Architectural Review Board

Meeting Minutes

November 13, 2019

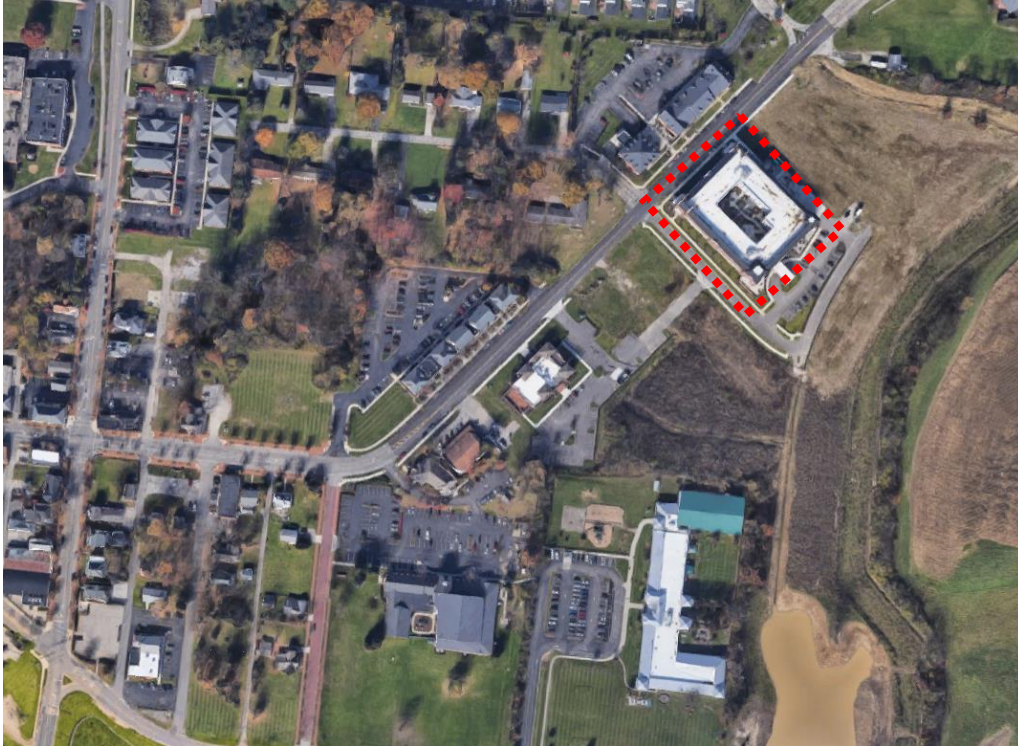
1. *The compliance of the application with the Design Guidelines and Requirements and Codified Ordinances.*
 - Per the city's sign code section 1169.14(a) states each building or structure in the Village Core sub-district shall be allowed three (3) sign types including, but not limited to, projecting, awning and wall signs. There are currently three signs installed on the building including one wall sign on the northern, side elevation and two blade signs.

- City sign code Chapter 1169.16(d) permits a maximum area of 40 square feet based on the building's frontage and allows one wall sign per business entrance and requires a minimum sign relief of one inch. External illumination is allowed. The applicant proposes one wall sign with the following dimensions:

- a. Size: 201"x 42" [Does not meet code due to area. Waiver requested].
 - b. Area: 58.63 square feet [Does not meet code. Waiver requested].
 - c. Location: the sign is proposed on the southern, Miller Avenue elevation on center between the second and third story floor windows. [meets code].
